THE MARYLAND ZOO IN BALTIMORE

PERIMETER GATE REPORT

SEPTEMBER 2021

#10/11 MANSION HOUSE STEPS SLIDE GATE

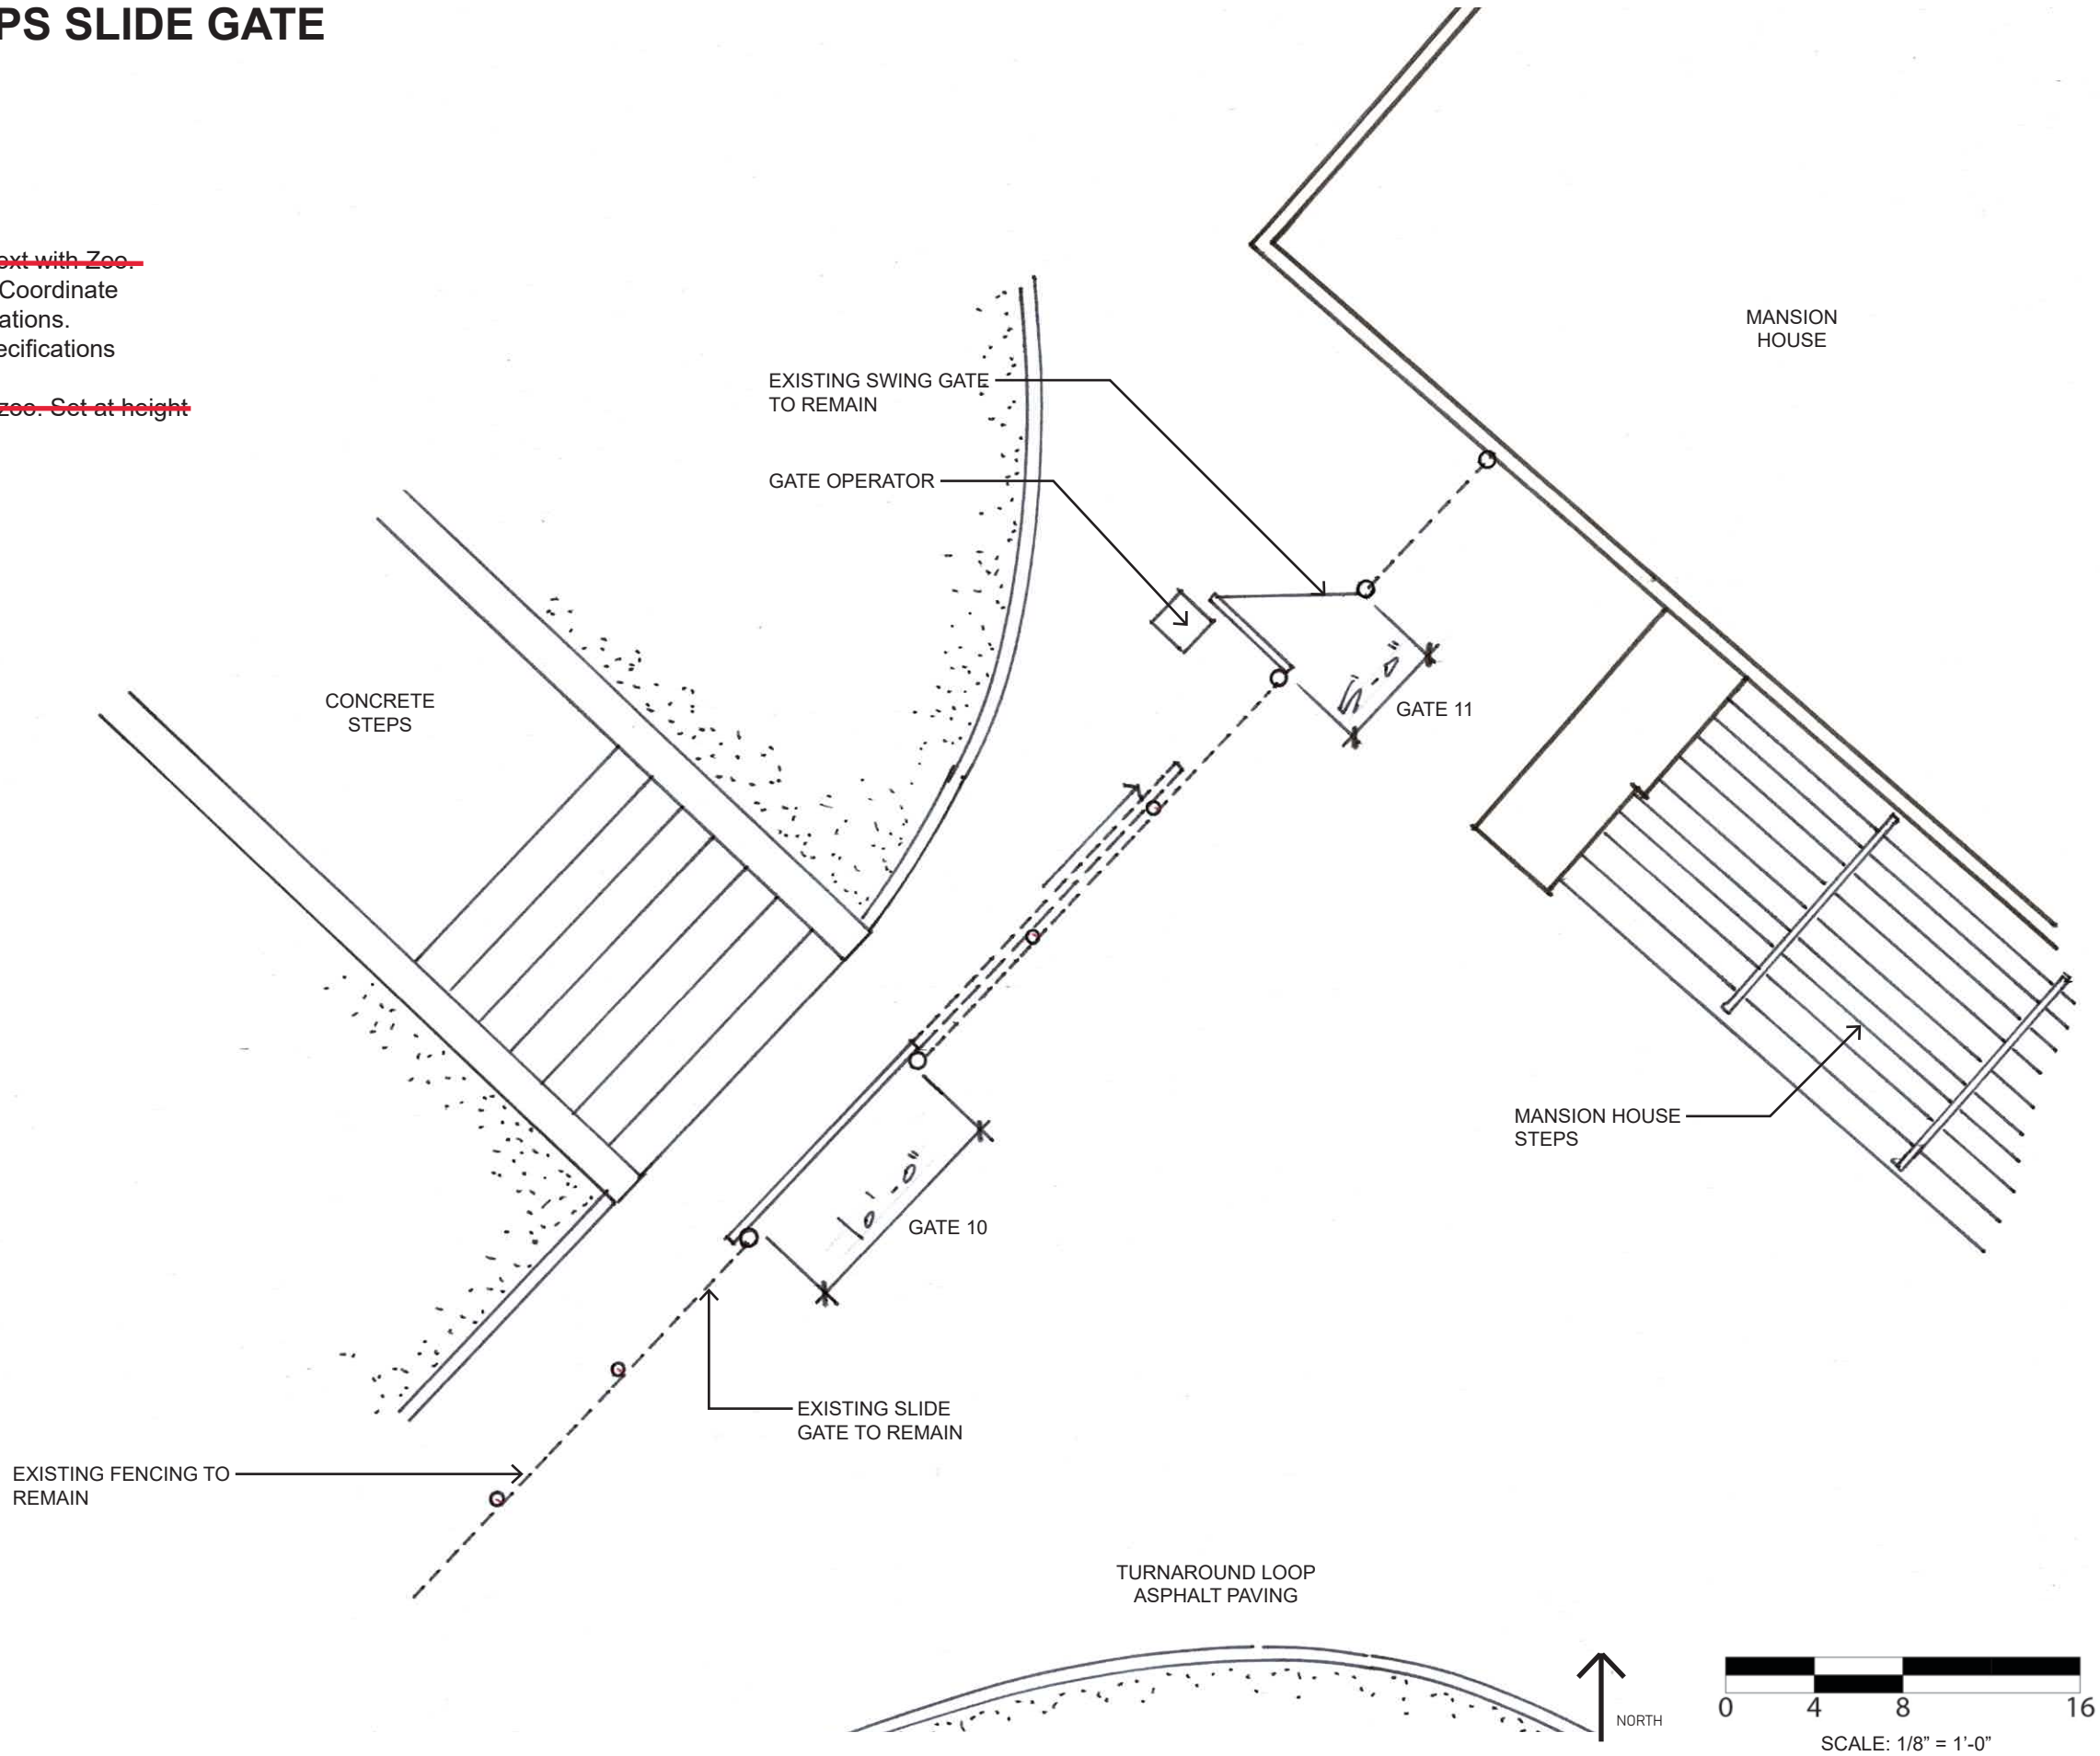
- ~~New sign to match "New Zoo Standard" coordinate text with Zoo.~~
- Gate 10:** Replace broken roller on manual slide gate. Coordinate product with zoo, prepare using manufacturer specifications.
- Gate 11:** Repair electric coupling mechanism. Use specifications provided by manufacturer.
- ~~Add call box. Coordinate placement and product with zoo. Set at height proposed by manufacturer.~~

#12 DEVELOPMENT GATE

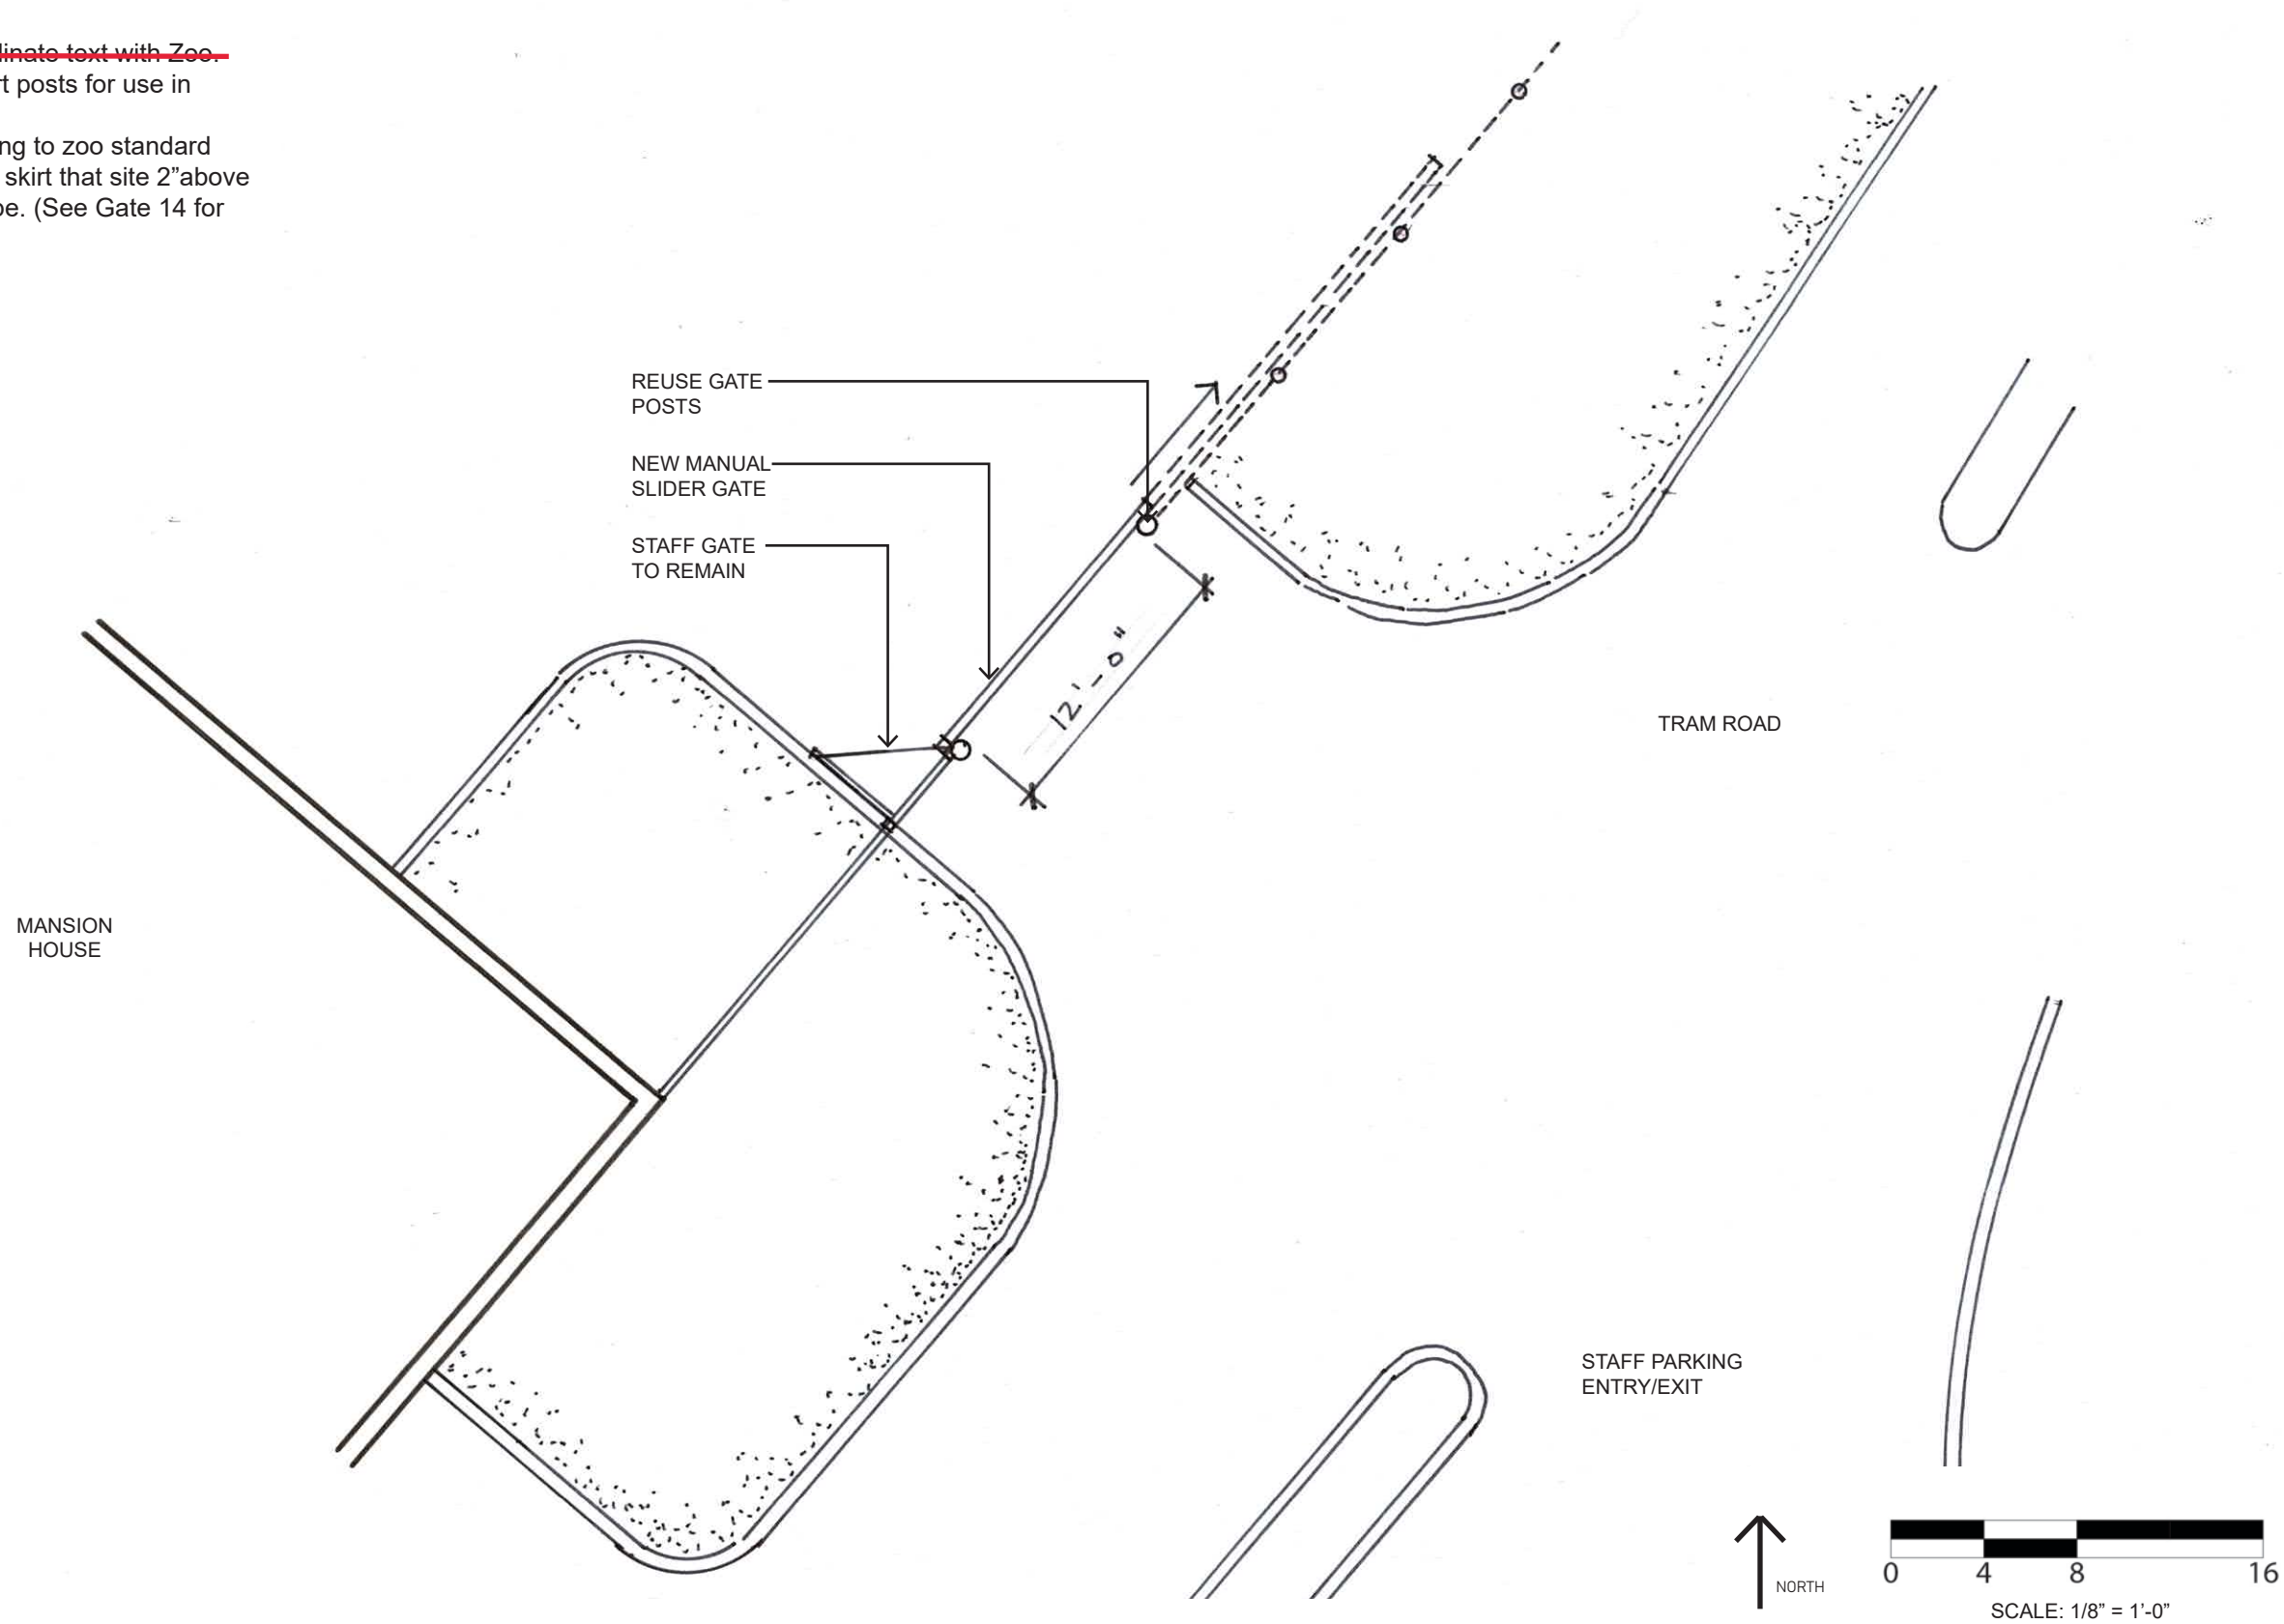
- ~~New sign to match "New Zoo Standard" coordinate text with Zoo.~~
- Remove existing gate and keep the two support posts for use in replacement build.
- Build manual slide gate, 12 ft in length, according to zoo standard specifications. Gate should have a sheet metal skirt that sits 2" above grade when gate is closed. Skirt will match slope. (See Gate 14 for reference).
- Match skirt on Gate #14.

15 EDUCATION GATE

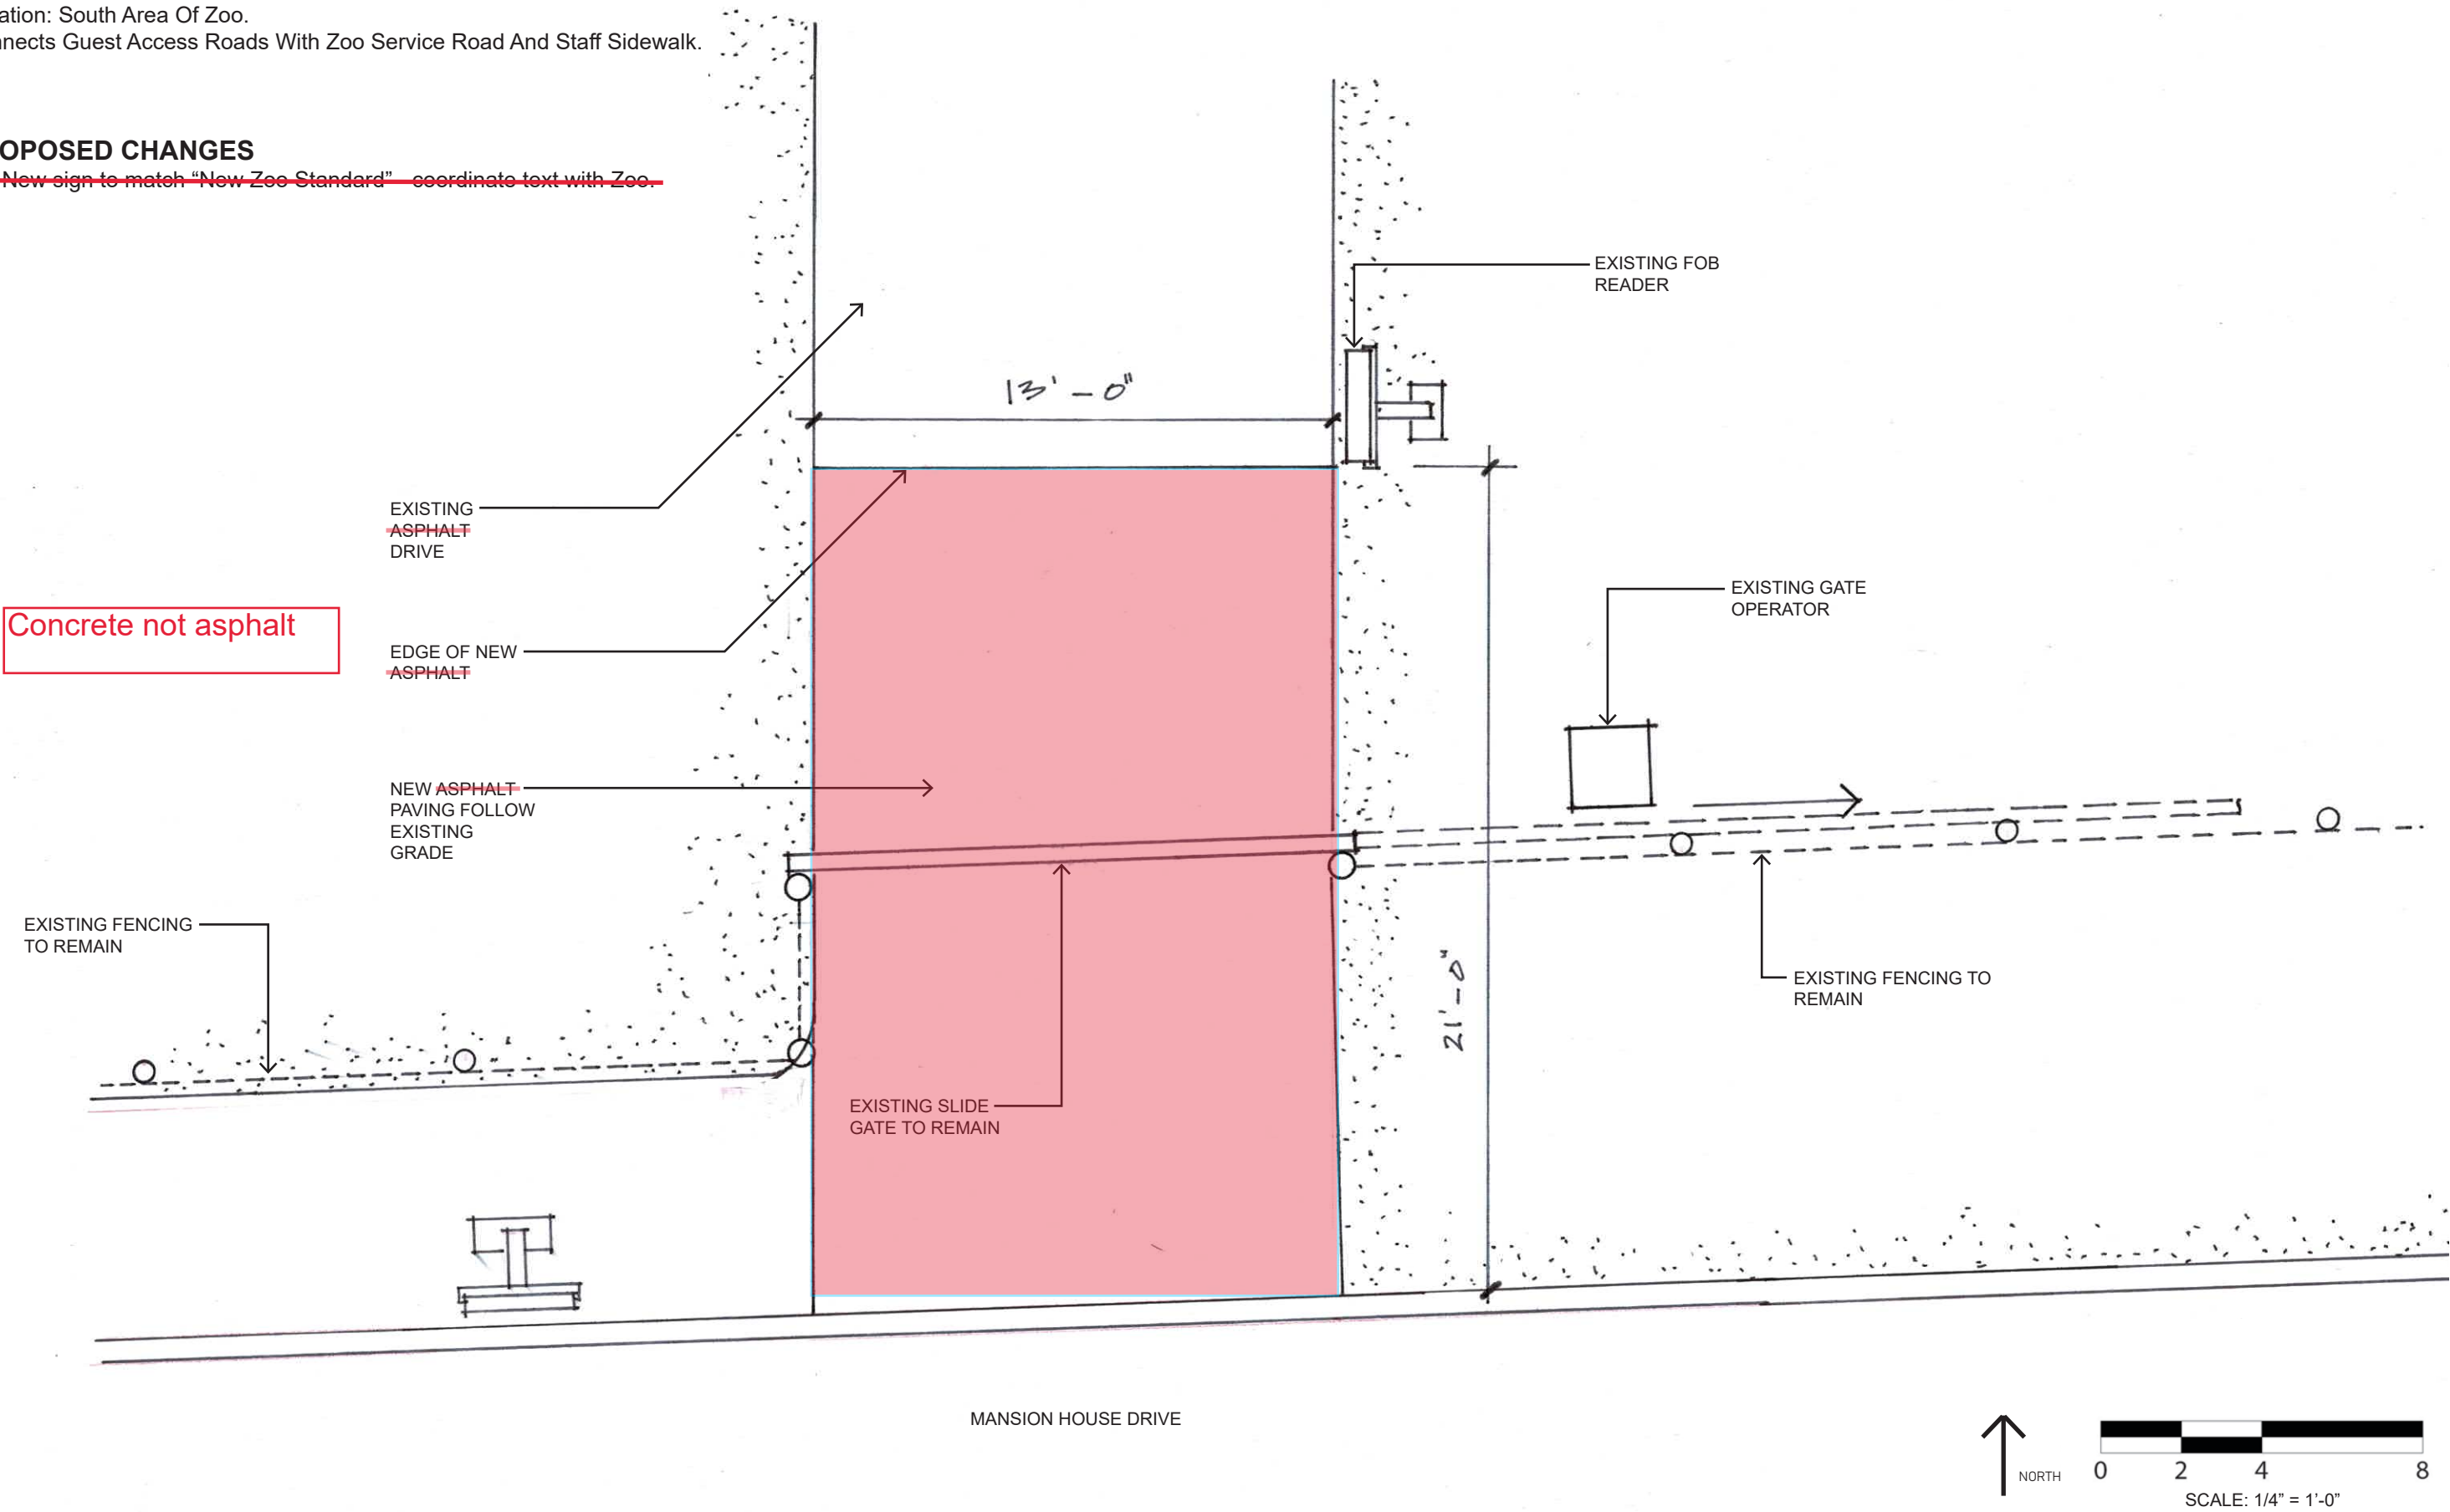
- ~~New sign to match "New Zoo Standard" coordinate text with Zoo.~~

Concrete not asphalt
